Hawker Siddeley Electronics Limited

FERRIS PRODUCTS DIVISION

BULLETIN TO FERRIS CAR RADIO SERVICE CENTRES:SUBJECT:

## SLIPPING MANUAL TUNING CONTROL

SEE OVER-DIAGRAMS 1, 2 & 3

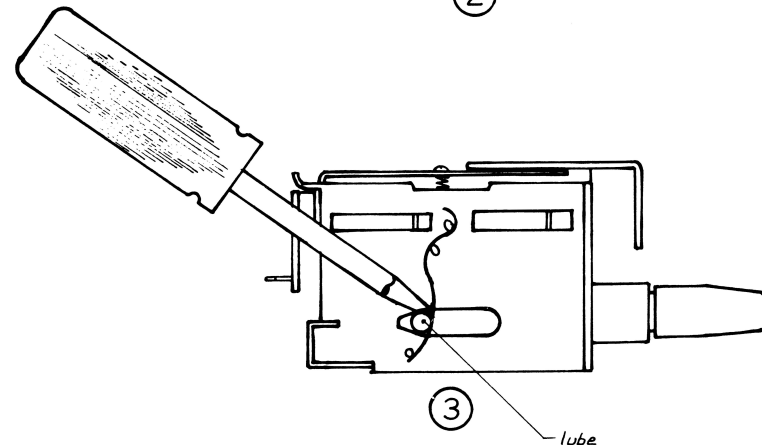
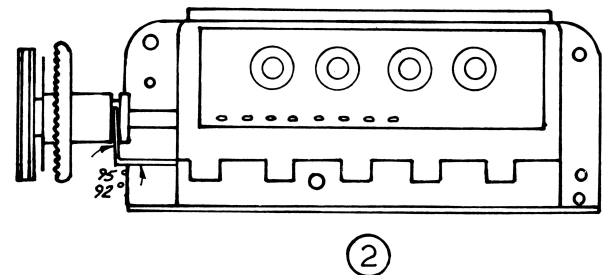
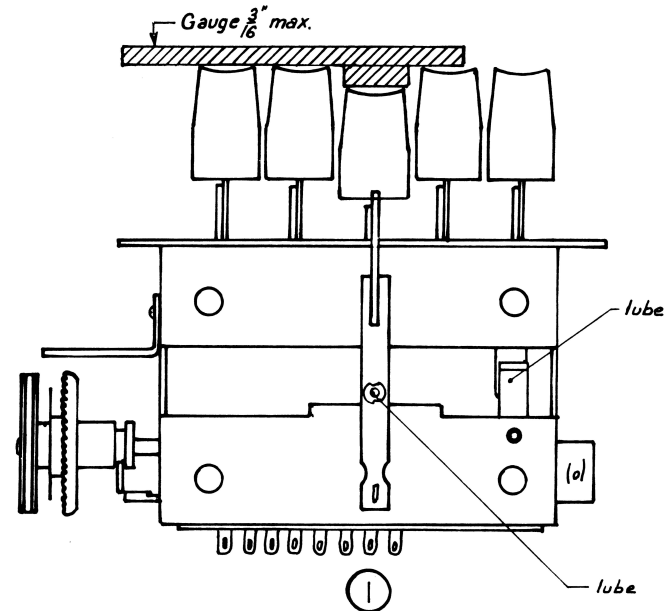
1. Test for free play in button movement. For correct clutch operation, from 1/8" to 3/16" free play should exist (see Fig. 1.)
2. If button free play is less than 1/8" bend clutch lever, using long nosed pliers or a suitable tool, to the angle shown in Fig. 2. — 92° to 95° approx.
3. Check tension on rocker shaft springs on each side of tuner. If excessive, bend spring as shown in Fig. 3., using a screwdriver to relieve pressure.
4. Apply a small amount of soft grease to all friction points. (See arrows marked 'lube' — Figs. 1 & 3).

**M157-NEW OUTPUT STAGE****FERRIS BROS. PTY. LTD.****BULLETIN TO FERRIS CAR RADIO SERVICE CENTRES:****SUBJECTS:**

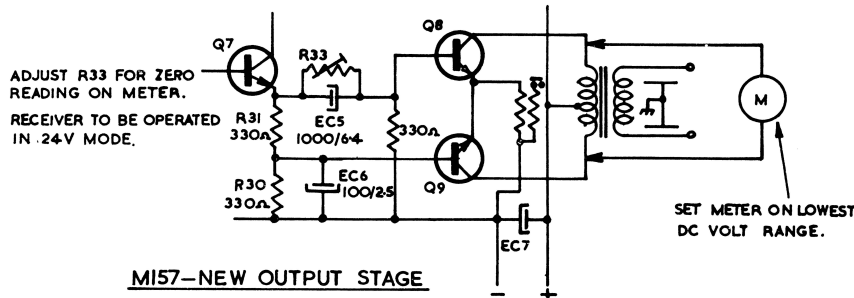
When M157 bus sets are returned for service due to transistor failure in the output stage, the following modification should be implemented (refer to M157 circuit diagram):-

- (1) Replace 2N3055 transistors.
- (2) Change resistors R30 and R31 from 150 ohm to 330 ohm ½ watt 10%.
- (3) Disconnect choke L6 (8132) from circuit.
- (4) Fit a 330 ohm 10% ½ watt resistor from negative rail to base circuit of Q8 (install resistor on printed circuit board).

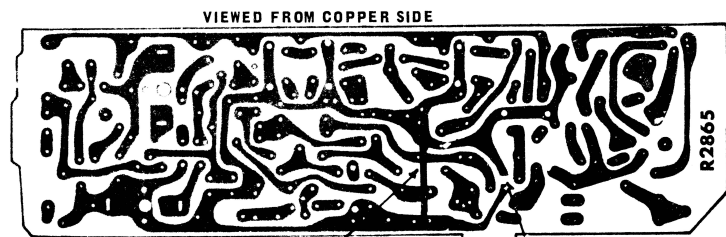
- a) Remove R20 (470 ohm  $\frac{1}{2}$  watt resistor).
- b) Remove Q5 (BC157 transistor).
- c) Remove green lead from base of Q6 (2N3054) and PC board.
- d) Connect 330 ohm  $\frac{1}{2}$  watt resistor, leaving one pigtail long enough to extend and solder to negative rail (see FIG. 1).
- e) Install OC955 or OC952 transistor in place of Q5.
- f) Connect a green lead of sufficient length to connect between base of Q6 and collector of Q5. Pass lead around end of PC board. (FIG. 1).

FIG. 2 shows the electrical details of the modified circuit.

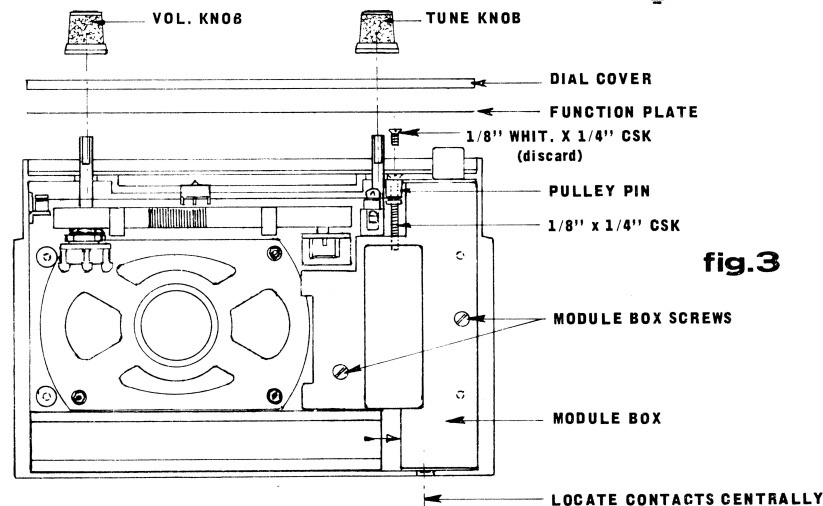
Early production model 304 receivers may suffer from misalignment of the left hand dial cord pulley pin, due to distortion of its plastic mounting bracket. This problem should be corrected as follows (refer FIG. 3):

- a) Remove four screws at rear of case and remove rear lid.
- b) Pull off volume and tuning knobs from spindles.
- c) Slacken the two module box screws.
- d) Remove dial cover and function plate.
- e) Remove and discard the  $\frac{1}{8}$ " Whit. x  $\frac{1}{4}$ " countersunk head screw securing pulley pin to case. Hold pulley pin against spring tension with long nose pliers.
- f) Refit pulley pin to case with an  $\frac{1}{8}$ " Whit. x  $\frac{1}{4}$ " countersunk head screw. Note that end of screw must enter hole provided in module box.
- g) Refit function plate and dial cover.
- h) Retighten module box screws whilst holding box against end of case to ensure that contacts are located centrally in case slot.
- i) Replace rear lid and secure with the four screws previously removed.
- j) Refit volume and tuning knobs.

In cases when Model 304 power cradle contact pins do not connect correctly with the concave contacts in the base of the receiver, it may be found that the contact strip is not aligned centrally in the slot in the receiver base. The following procedure should be carried out in such cases and whenever the receiver module box screws are loosened or removed (refer to FIG. 3).

fig.4

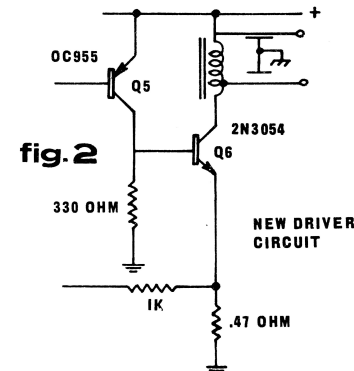
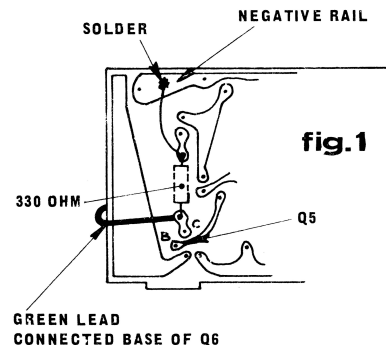
In some Model T010 receivers a heterodyne whistle occurs at 610 KHz (2FC Sydney). In such cases the following modification should be carried out - (refer to FIG. 4).

FIGURE 1

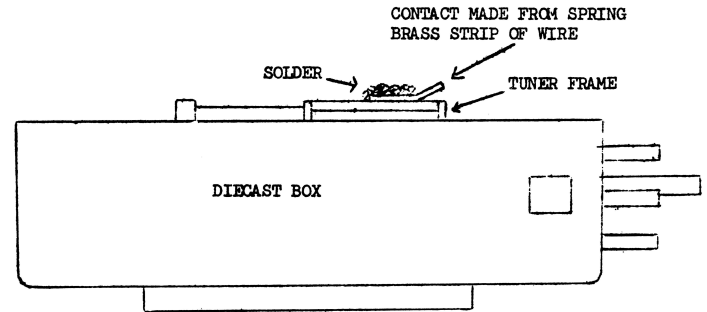
If interference persists, remove plastic rear lid from set and check fit of die cast lid on module box. This lid must make a firm electrical contact around its perimeter. This is especially important around the area near the push button switch. In stubborn cases, a small contact soldered to the top of the tuner frame and arranged to contact the under side of the die cast lid will help. See FIG.1.

FIGURE 2

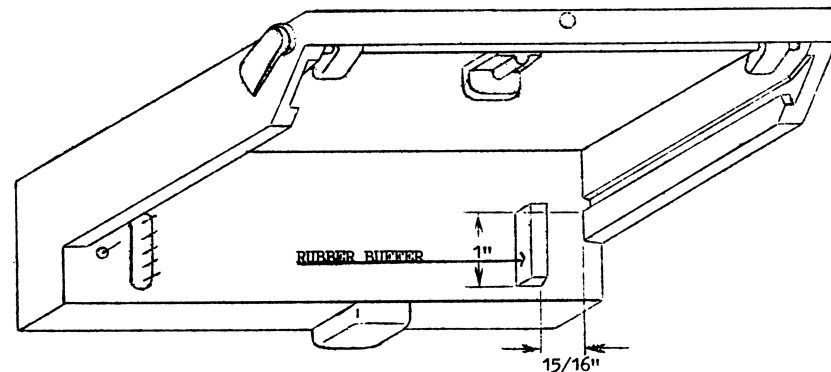
Early production Model 304 power cradles did not incorporate a rubber buffer to equalize forward pressure on both sides of the receiver base. Details of the modification now introduced in production to rectify this problem are as follows -

- (a) Obtain a pre-cut buffer - Part No. R2910 - or cut one from Dunlop Sponge Rubber Weather Strip (section A27).
- (b) Attach buffer to power cradle in the position shown in FIG.2 using a suitable contact adhesive.
